To: Jeff Fuller
Queenstown Lakes District Council

Project/File: 310205960 / 0784

Reference: FTAA - Mount Iron Junction Housing Scheme [FTAA-2602-1173]

Figure 2-1: Average daily volume on SH4 by week in 2025 (July volume arrowed)

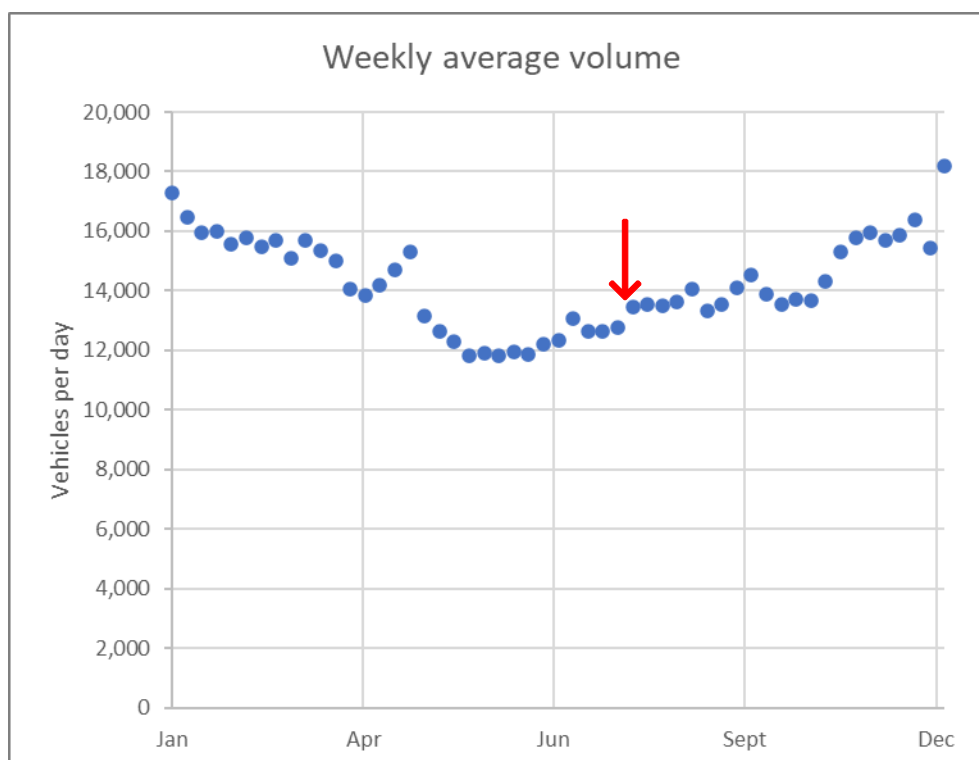
Figure 2-1 shows the average daily volume of traffic that I have calculated using NZTA count data on a week by week basis for 2025 on State Highway 84. It indicates that there are strong seasonal variations in traffic movements with the lowest volumes being recorded in the middle of the year and the highest volumes in the summer months. Traffic volumes at the end of July were about 7% lower than the annual average, and nearly 20% below the 90th percentile level.

Adopting the July survey data as a basis for assessing future growth creates a risk that the growth rate has been underestimated and as a consequence, the existing spare capacity of the roundabout has been over-estimated.

There is also a concern that the Applicant's SIDRA model is not well calibrated to existing conditions as it reports queues of nine vehicles on the SH84 approach compared with the observed queue lengths reported in the ITA of 30 or more vehicles. My observations in the evening peak in April 2026 recorded queues extending beyond the Puzzling World entrance, that is, queue lengths of more than 800 m.
